# LBHA Airspace Change Proposal ACP-2018-69

Options Development & Design Principles Evaluation

Reference	Description
<b>Document Title</b>	LBHA Airspace Change Proposal
	Options Development & Design Principles Evaluation
<b>Document Ref</b>	71311 011
<b>Issue</b>	Issue 1
<b>Date</b>	27 <sup>th</sup> January 2023
<b>Client Name</b>	London Biggin Hill Airport
<b>Classification</b>

Figure 7 – Runway 21 East 2

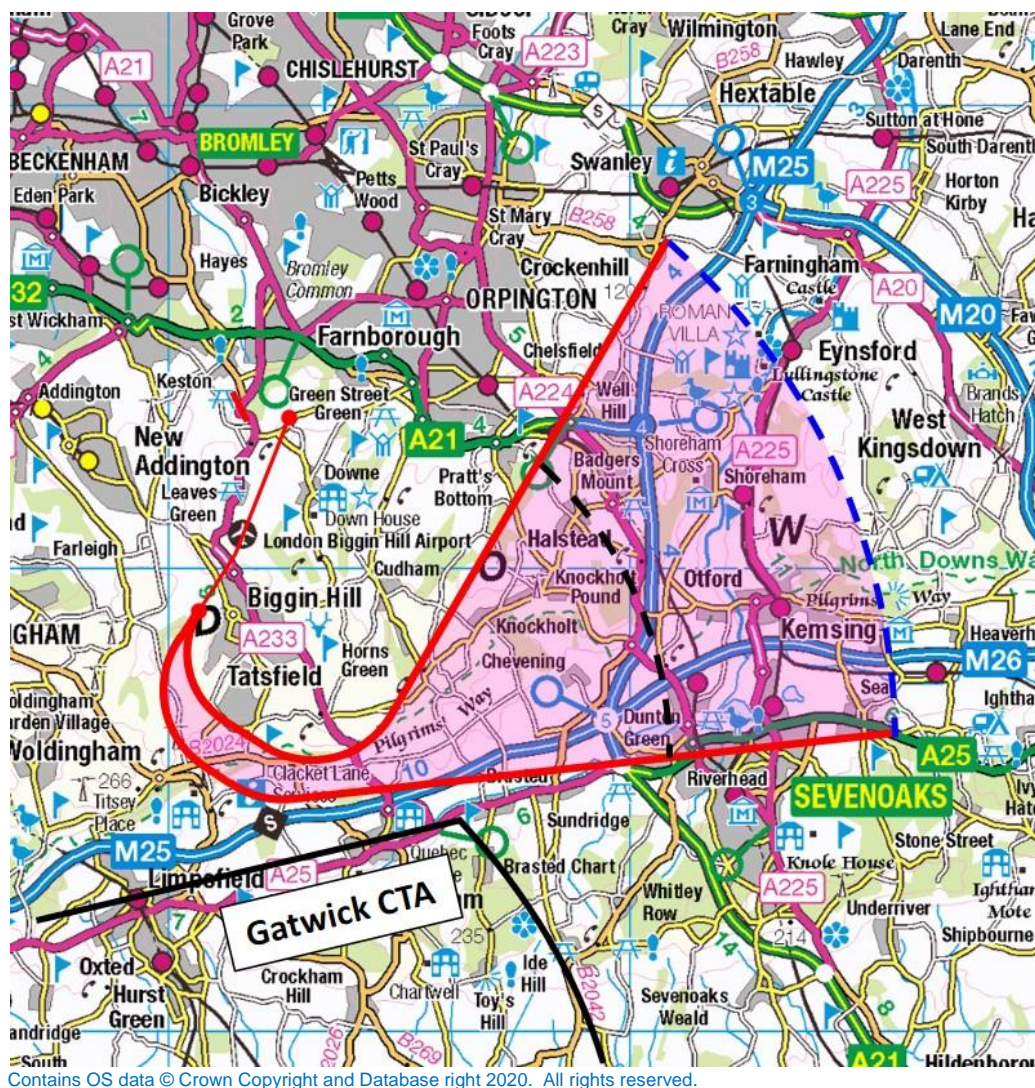
<p>Option D4 (extension/additional option): NERL would like to suggest extending the swathe to the south in the vicinity of Sevenoaks. Whilst this would need deconflicting with the Gatwick operation, this extension may increase flexibility in Stage 3.</p> <p>Arrivals – Swathe length: NERL would like to suggest the lengthening of all the arrival swathes to incorporate the airspace, be it for an RMA or transitions, between ALKIN and Biggin Hill.</p> <p>Option A1 (extension/additional option): NERL would like to suggest extending the swathe to the north east in the vicinity of Brentwood. This would facilitate a shorter route into ATPEV from the north. NERL would also suggest the removal of the vertical profile displayed on this option. As sponsors progress through the process the vertical profile on the route depicted may prove overly restrictive.</p> <p>Option A3 (extension/additional option): NERL would like to suggest extending the western swathe further into the LL CTA. This would facilitate flexibility for both the positioning of the specific route and tactical options available to appropriately manage the traffic.</p> <p>I would like to confirm, for your records, that NERL has no additional feedback on these two options.</p>	<p>achievable. Further development work will be undertaken during Stage 3 of the CAP 1616 process which may result in increased ranges to achieve 7,000 ft to ensure safe separation from adjacent airport operations.</p> <p>There is no reason why the arrival swathe cannot be extended to the north east to improve arrivals from the north, although Southend and London City operations would need to be considered. The heights are indicative only to show how the procedure is flown today and can be subject to further work to achieve an optimal profile.</p> <p>There is no reason why the swathe cannot be extended further west and this will be considered as the swathes are developed.</p>

Figure 13 – Runway 03 North 1

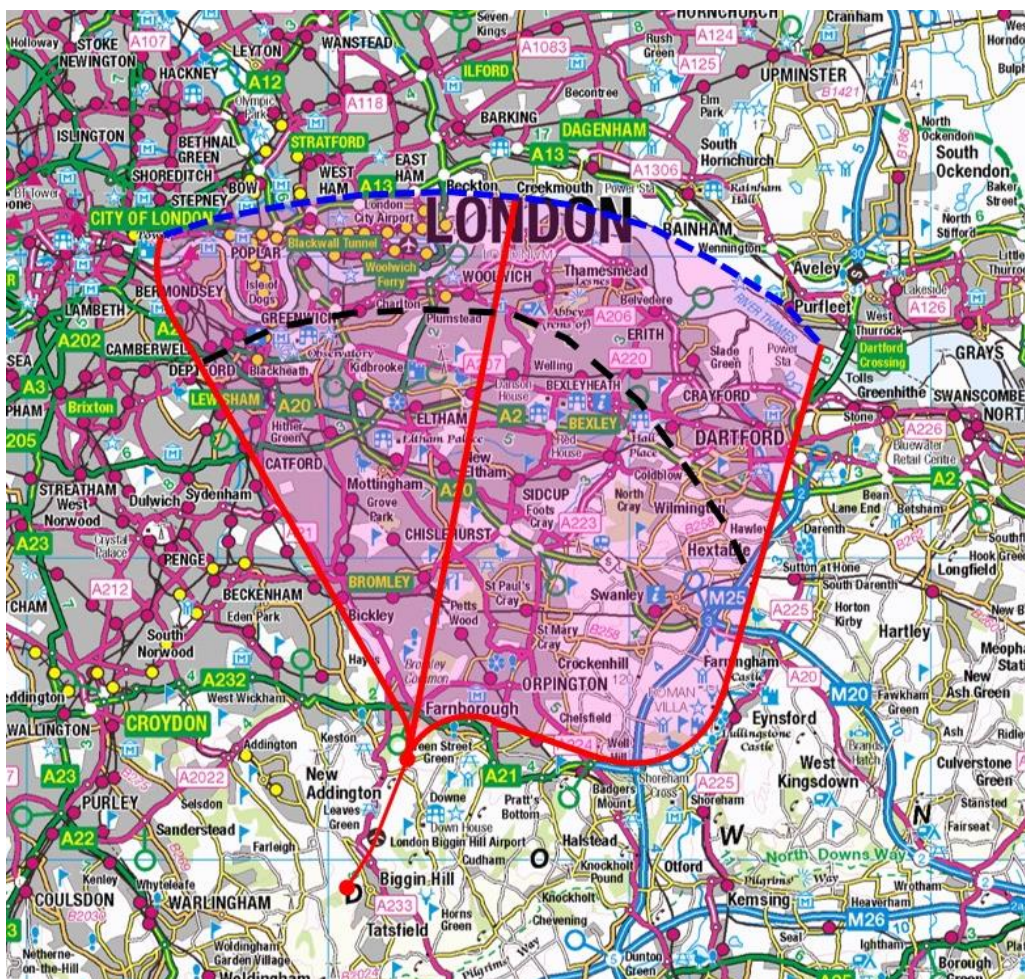
<p>10. Option D10 demonstrates point 9 above. It affects most of the built-up areas of the borough of Bromley, which the current NPR is devised to protect and is therefore not worthy of consideration.</p> <p>In answer to your question whether all the options have been considered, we would say that relevant ones, such as the new approach to R03, have not been, and we regret to say that the ones presented do not appear to be an improvement on the current situation. It seems to be a missed opportunity.</p>	<p>6. The departure swathe has been derived from actual radar track data. The nominal track routes aircraft through the centre of the runway. However, variations in aircraft types, navigation equipment, weather and piloting techniques result in aircraft being dispersed about the nominal track line.</p> <p>7. Do Nothing is not an option because all major airfields in the UK are engaged in making changes to meet the requirements of this National reorganisation of the UK Airspace, above and below 7000ft. For more information, please see the ACOG information website, One Sky One Plan.</p> <p>8. By introducing new routes to a PBN standard, LBHA aims to improve the current impact of noise on the local population.</p> <p>9. The swathes represents the full suite of options of where a route could go. Further analysis will be conducted as more defined routes are developed within the swathes.</p> <p>10. The Initial Options Appraisal will analyse the impact of each of</p>

<p>the options to see if they can be taken forward to the next stage.</p> <p>In accordance with the CAA CAP1616 process, we are required to look at all possible route options into and out of Biggin Hill Airport. Final routes will be established during Stage 3, when a full evaluation can be conducted against our established Design Principles from Stage 1, which will also take into consideration the already established NPRs. This will also involve full engagement with our adjacent airfield and the National Air Traffic Services, which is being co-ordinated for the CAA and DfT, through the Airspace Change Organisation Group (ACOG).</p>
DAATM	<p>Agree that options have been designed with consideration for the agreed design principles.</p> <p>The MOD is keen to remain involved in engagement and consultation as this ACP progresses, but I would request that you retain both RAF Kenley and RAF Northolt as specific local airspace stakeholders while I represent wider MOD. I have already seen that Kenley offered some general feedback and am sure that you will continue to work closely with them to ensure suitable deconfliction between the two units, given their proximity.</p> <p>I would also like to iterate that we will be interested to see what the proposed increases in regulated airspace will look like and to understand how impact on other airspace users will be minimised</p>

Figure 14 – Runway 03 North 2

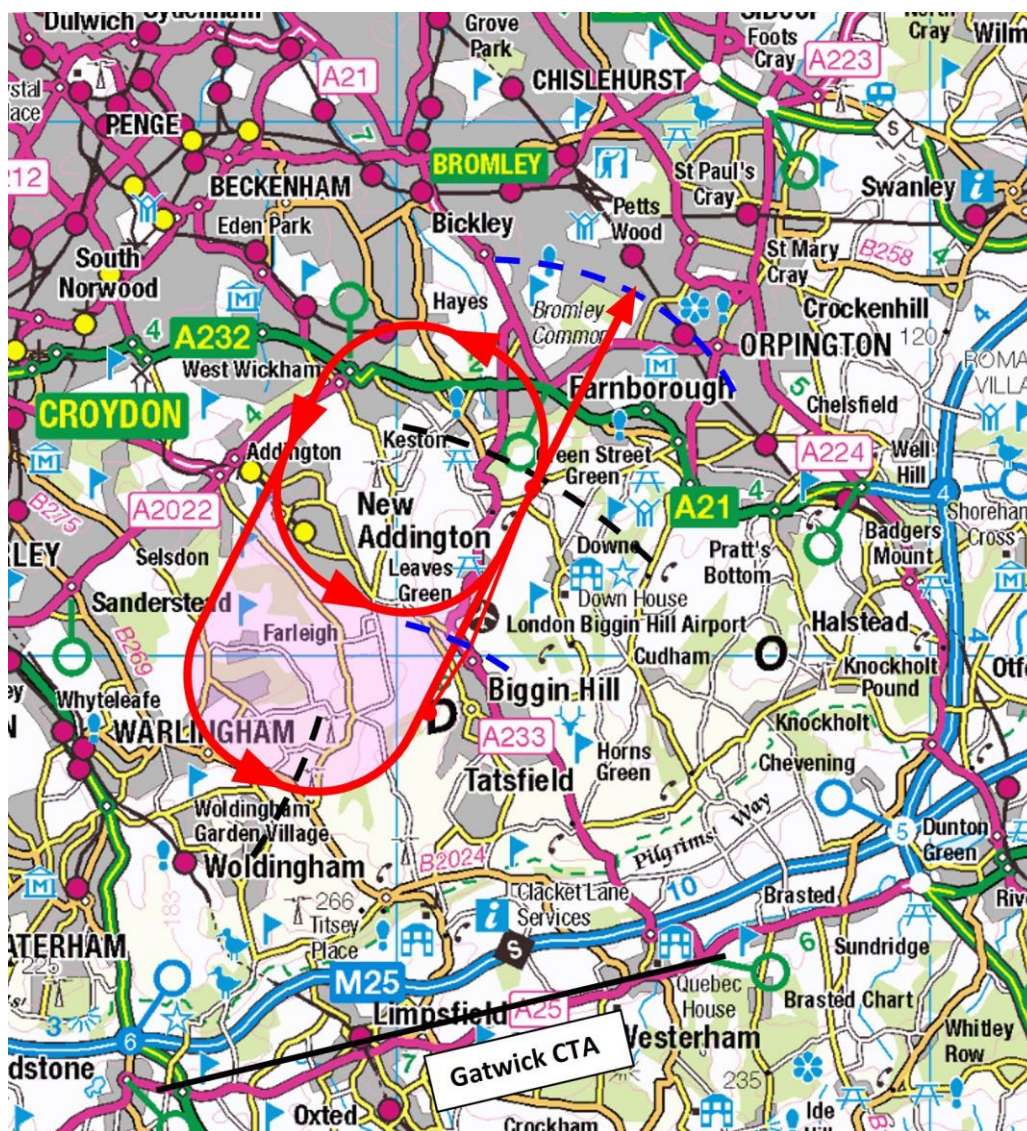
Individual	I am a Knockholt resident and I strongly oppose the right hand flight path which is 10b.	
Individual	Of the 2 suggestions for the South Airspace Change we prefer option 10a 03 North LH	
Individual	Biggin Hill Airport is part of the Bromley Borough and the newly proposed route for aircraft at Biggin Hill should therefore use the airspace over Bromley and not over the Sevenoaks District. Therefore route option 10a, with a Left Hand (LH) turn off runway 03, then back through Biggin Hill overhead proceeding North should be utilised rather than route 10b	
Individual	10a. 03 North LH appears to be less densely populated and therefore sound and air pollution would impact on fewer residents and so is our preferred option.	
Individual	I would like to state my preference for the proposed changes to be 10a. 03 North LH	
Individual	I would like to make my opinion on the preferred flight path from the airport which is 10a . 03 North LH.

Runway 03 departure to the north were introduced that turned south initially (left turn and right turn after take-off) before circling back over the airport to route north. These were included as options 10a and 10b and were subsequently shared with stakeholders.
Focus Group	Concern that the higher climb rates would create more noise on the ground.	Currently aircraft have to level at 2,400 ft before getting clearance to climb further. The aim of these options is for unconstrained climbs to 7,000 ft. The noise impacts will be modelled in more detail as we get closer to consultation. The type of aircraft that operate from Biggin Hill are lighter and had smaller engines and are much quieter than airliners. The noise impacts will be modelled in more detail at the next stage of the CAP 1616 process.
Focus Group	When aircraft currently take off and circle to route over the centre of the airfield the impact is much less. Some departing aircraft end up further north than the airfield boundary and this has a bigger impact. They stated that it would be helpful if any route options that circle back to pass over the airfield use the middle of the runway as a reference point.	This will be considered as the options develop.
